CIVIL CONSTRUCTION DRAWINGS  
FOR  
STEAMBOAT BASECAMP  
LOT 1 WORLDWEST SUBDIVISION  
1901 CURVE PLAZA, STEAMBOAT SPRINGS, CO 80487

Steamboat Basecamp - Phase I

REVIEW SET  
NOT FOR CONSTRUCTION  
8/5/21

SHEET: C.221

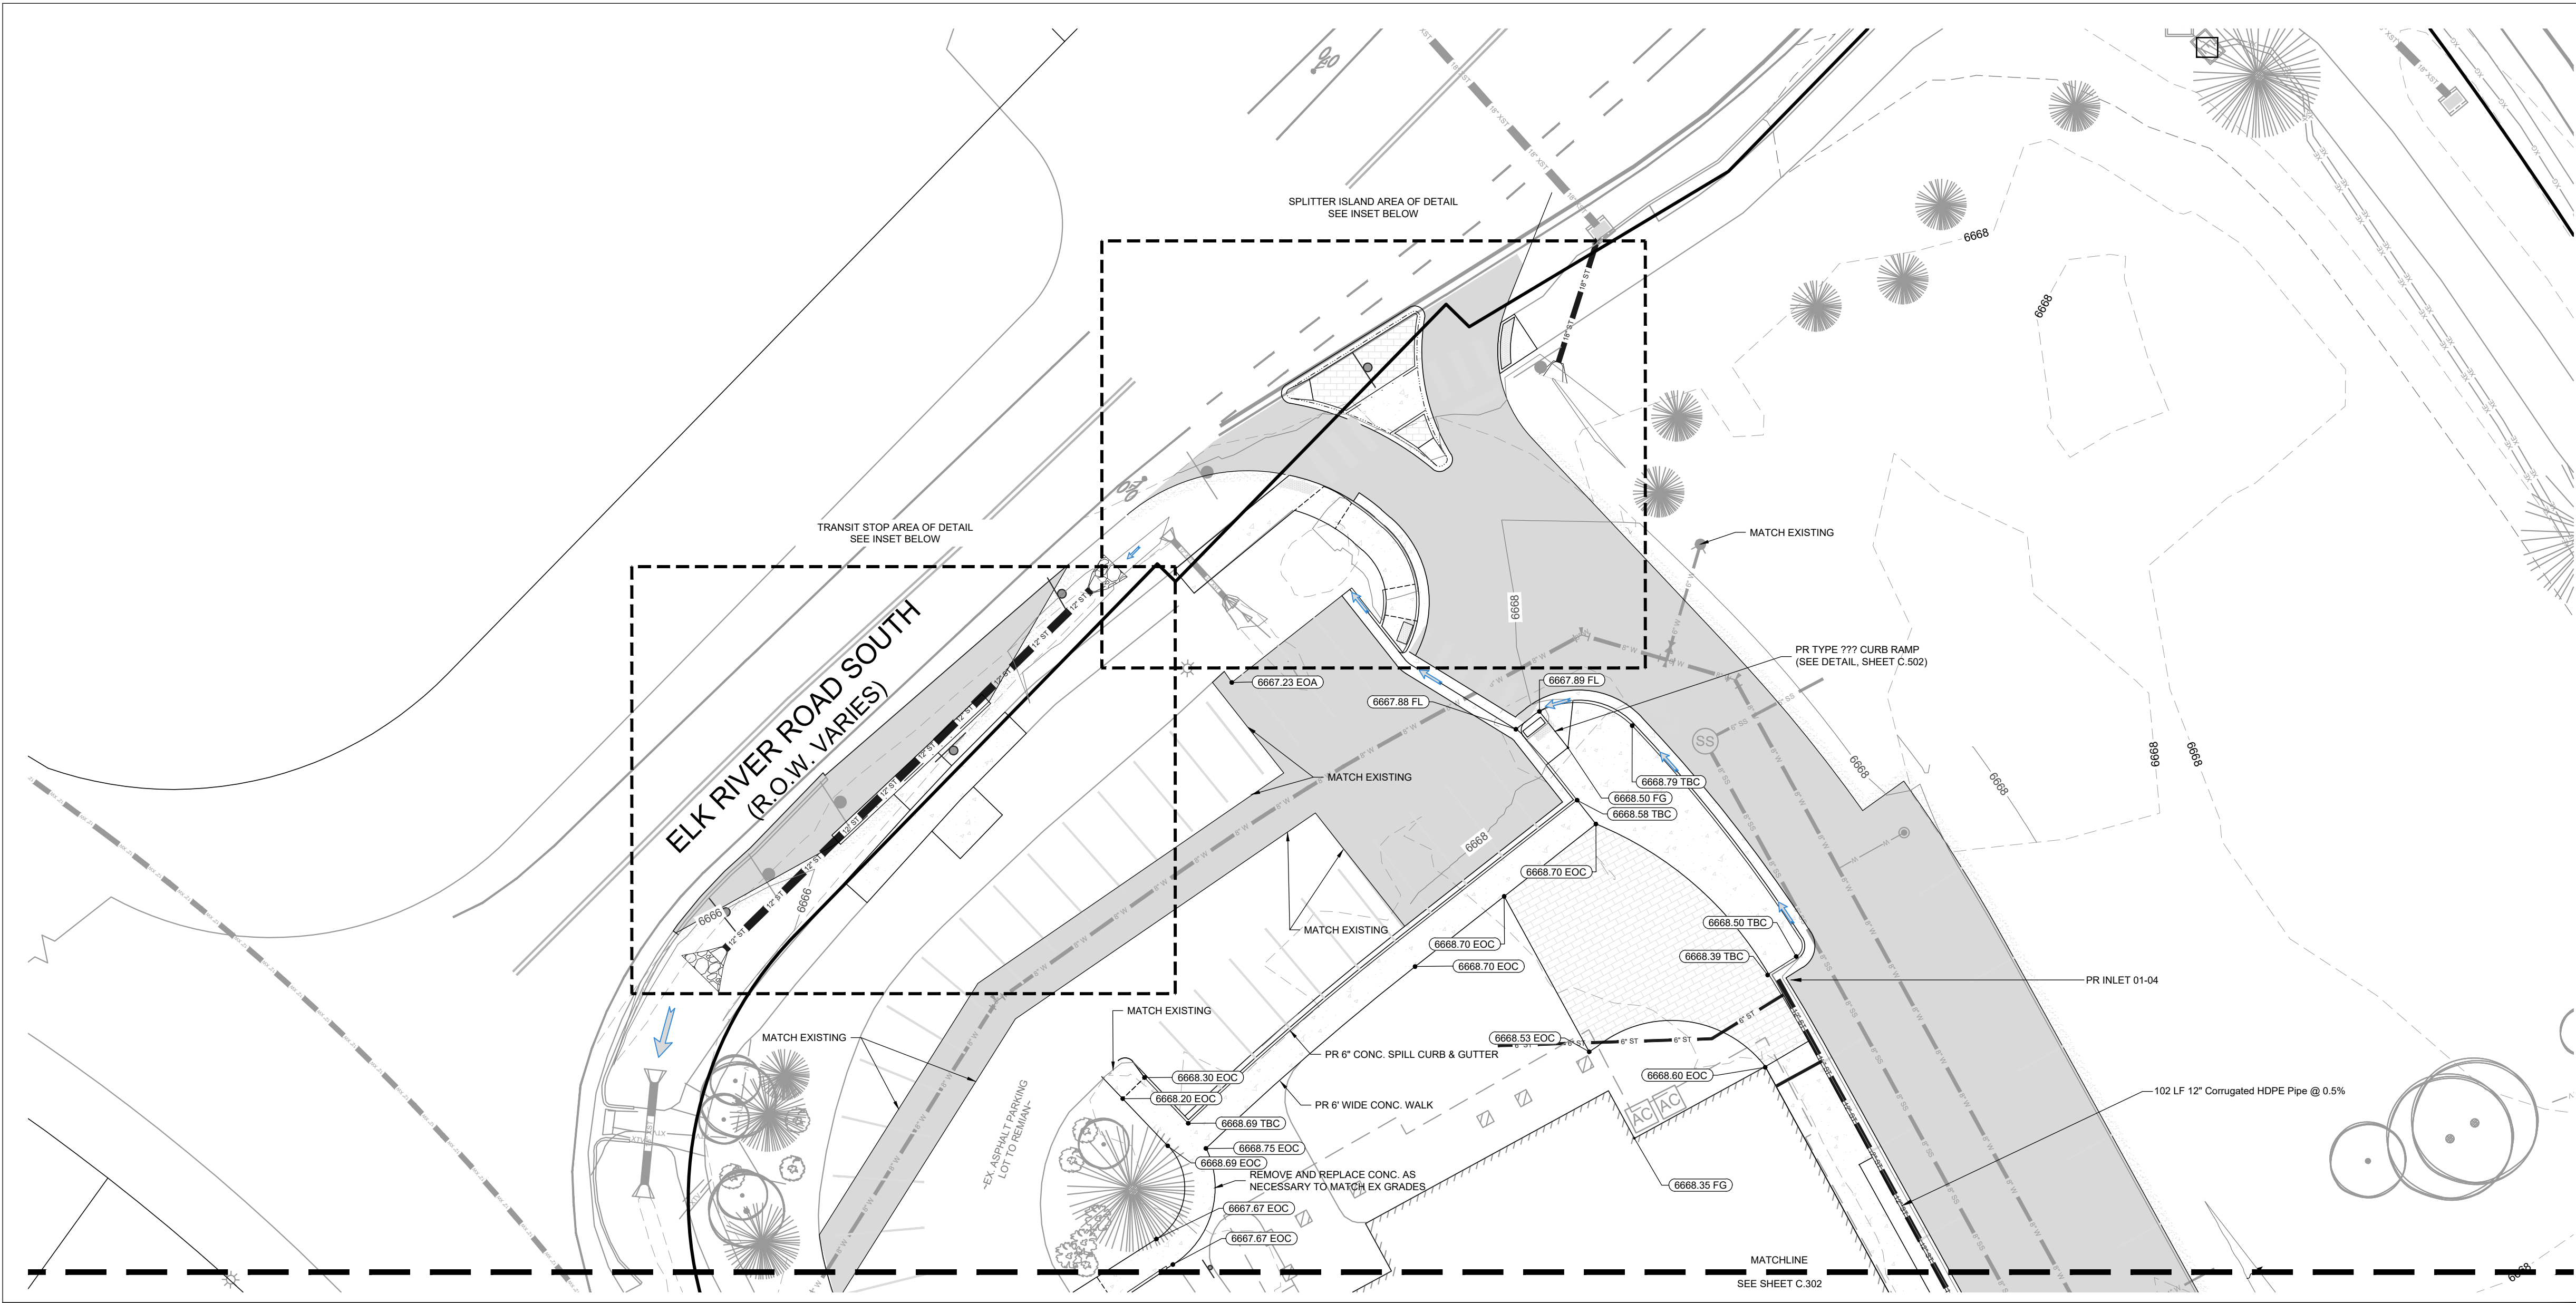
Remove this statement.  
The water and sanitary  
sewer mains have  
nothing to do with  
Basecamp per previous  
discussions. The  
acceptance will be  
associated with the  
future development in  
which the mains serve.

CONTINENTAL CROSS WALK STRIPING  
N.T.S.

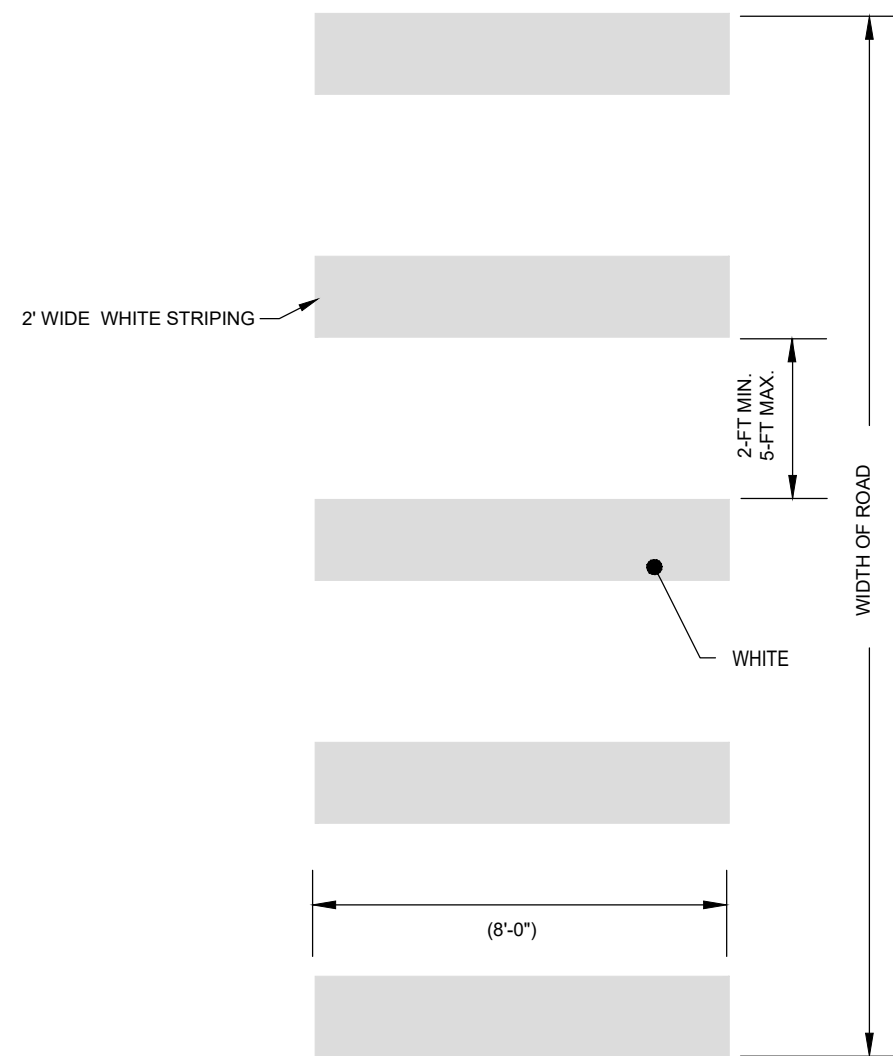
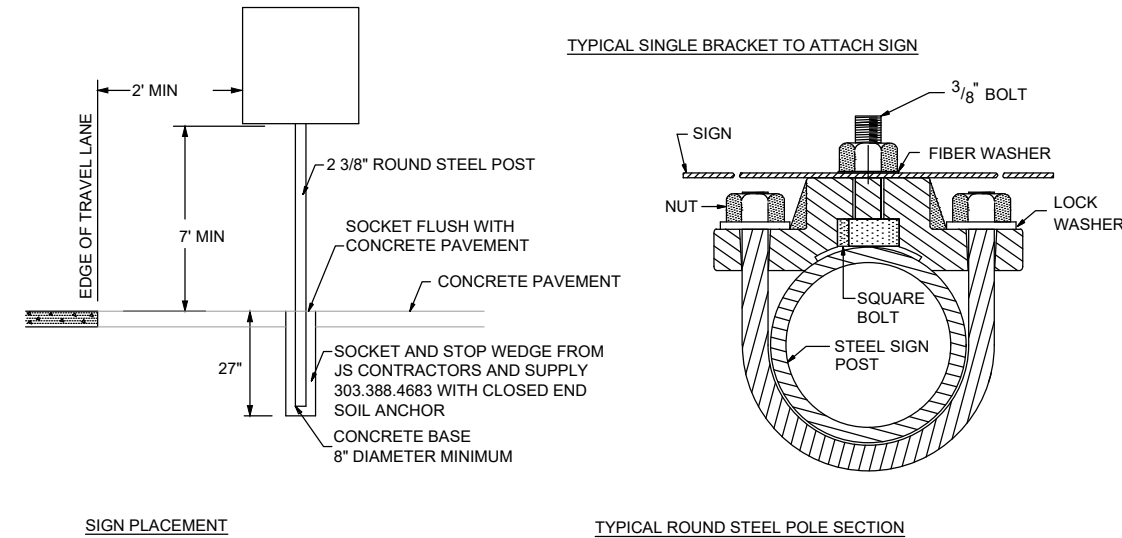
please see revised detail sheet for splitter island, delineator and striping...

STANDARD DETAILS  
GRATE AND FRAME - ADJUSTABLE  
CURB BOX  
S-716

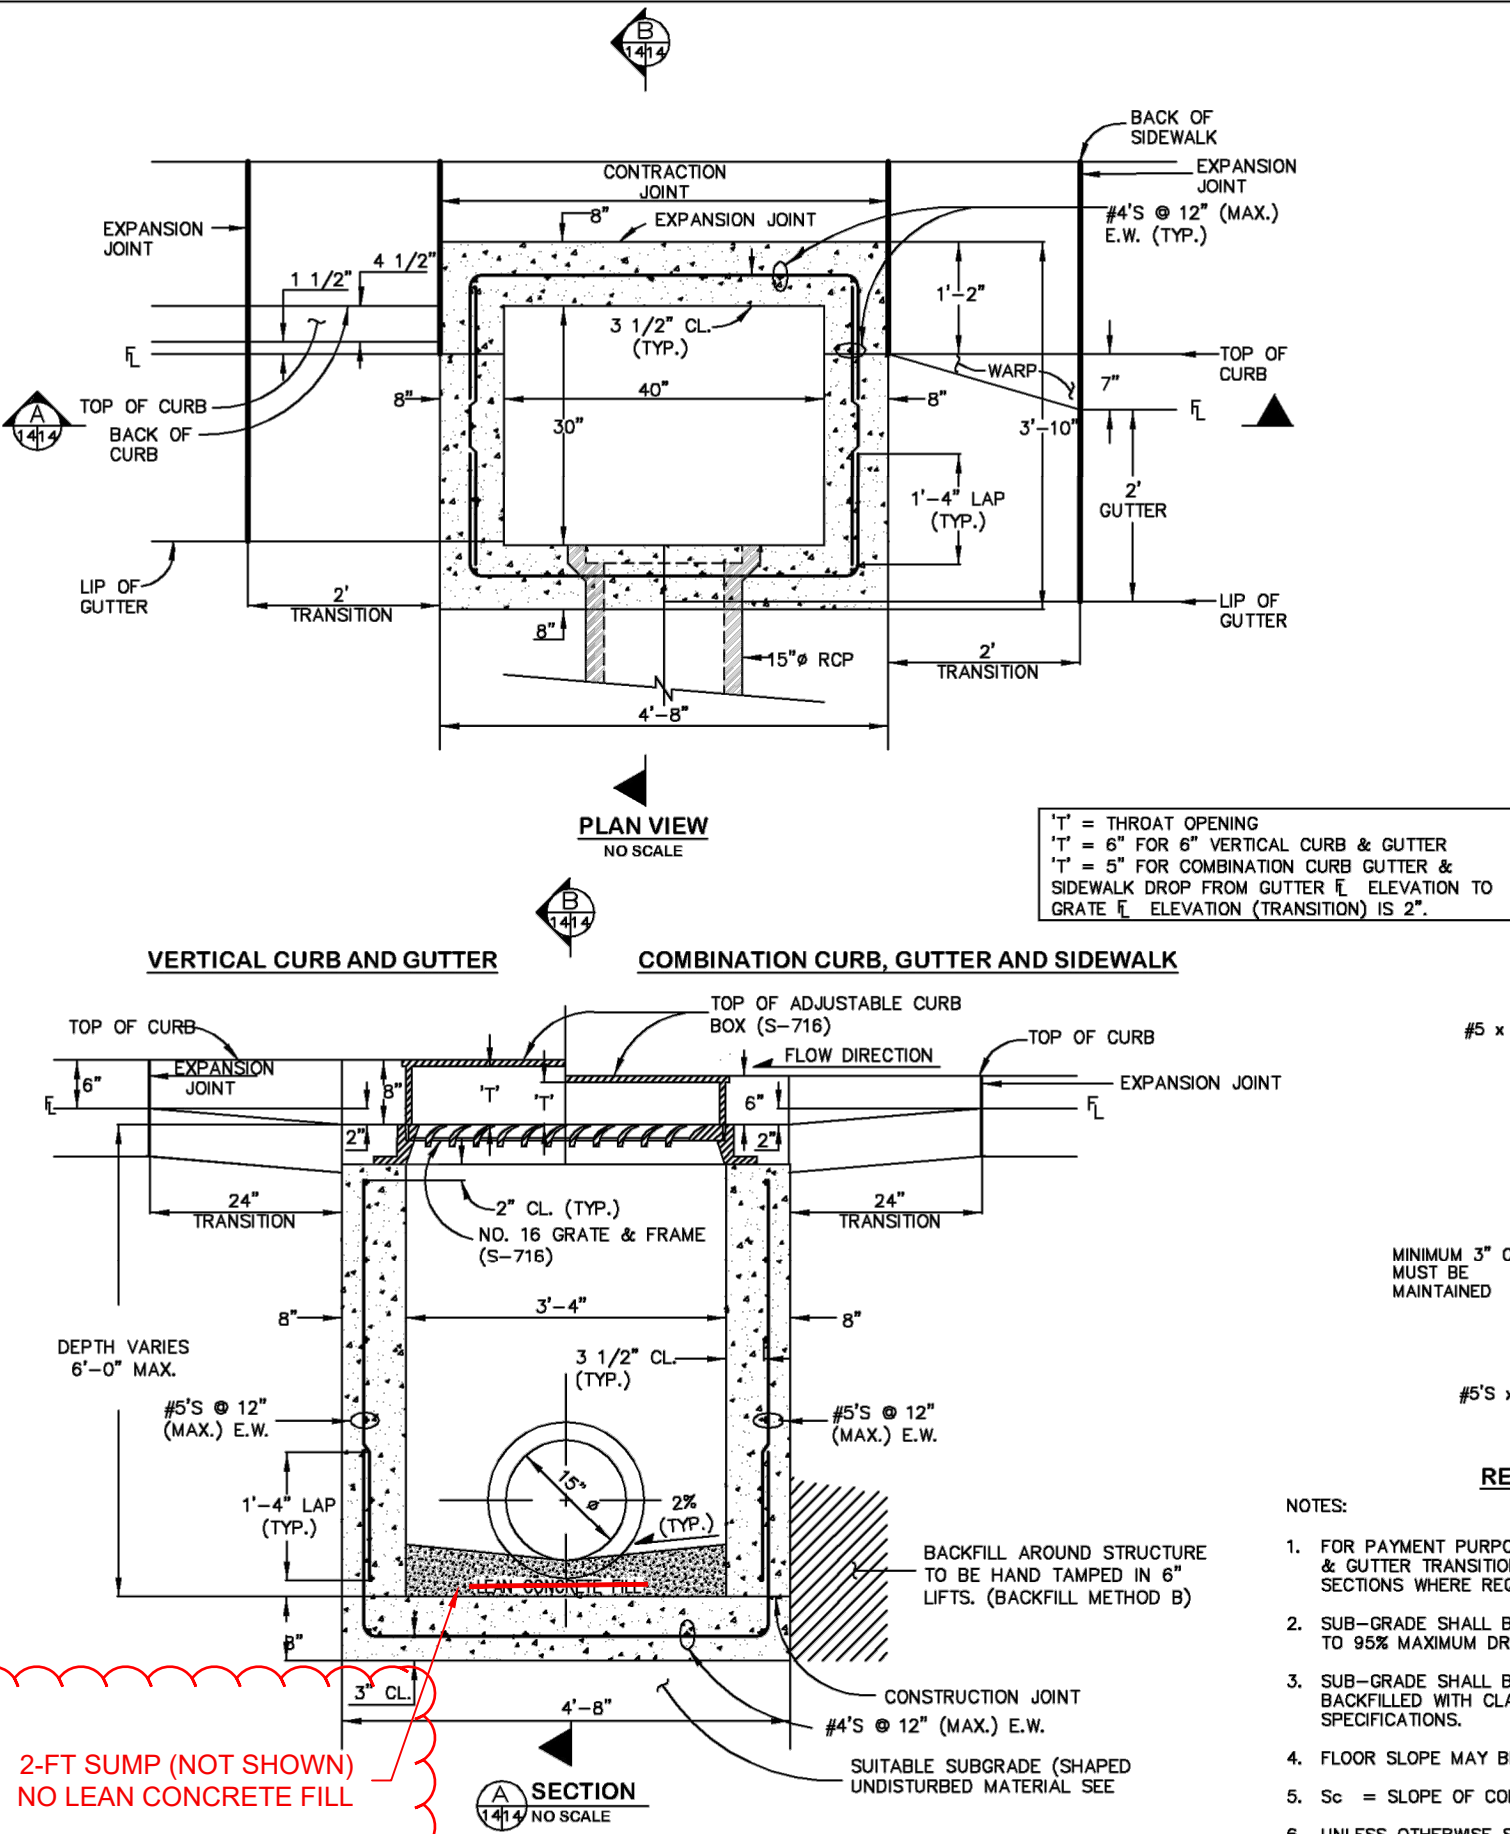
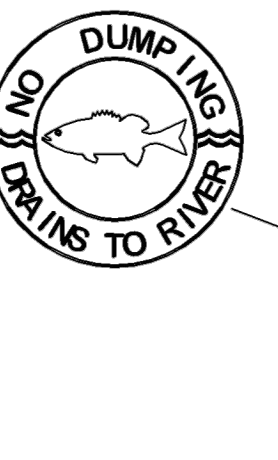
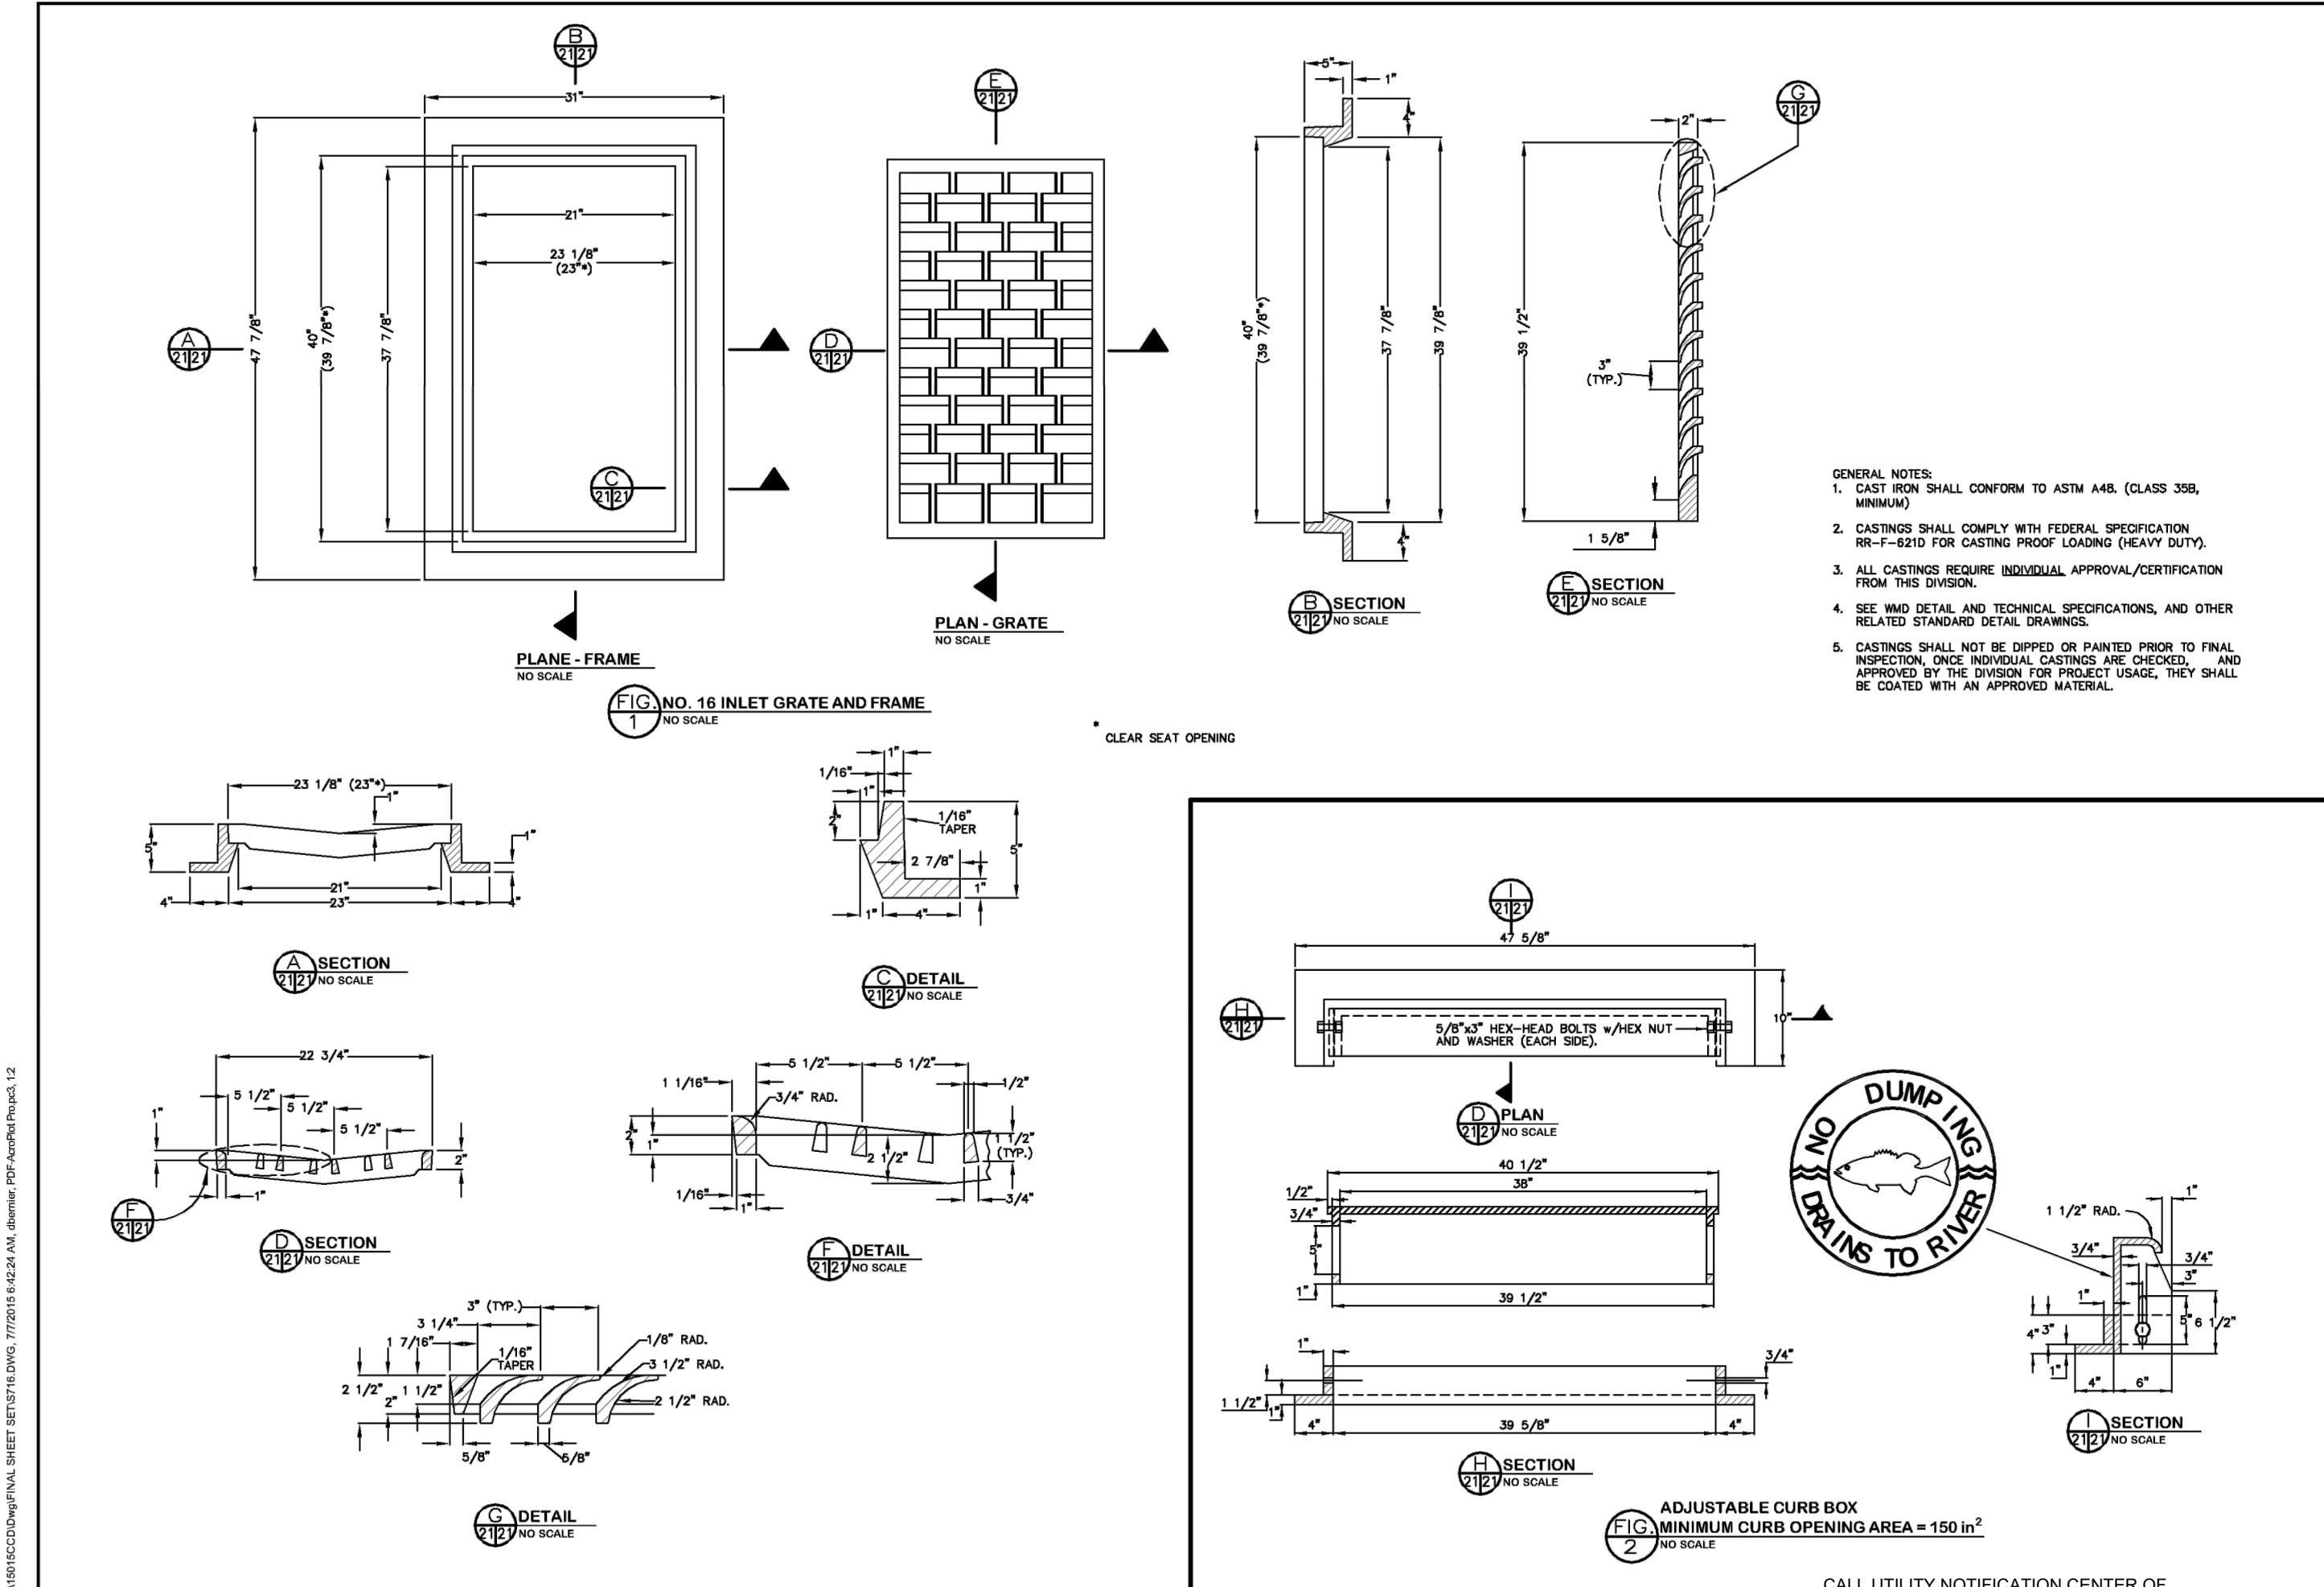
G.501\_Revise note  
working:  
&quot;Required 2 ft  
sump not shown. No  
lean concrete fill&quot;;
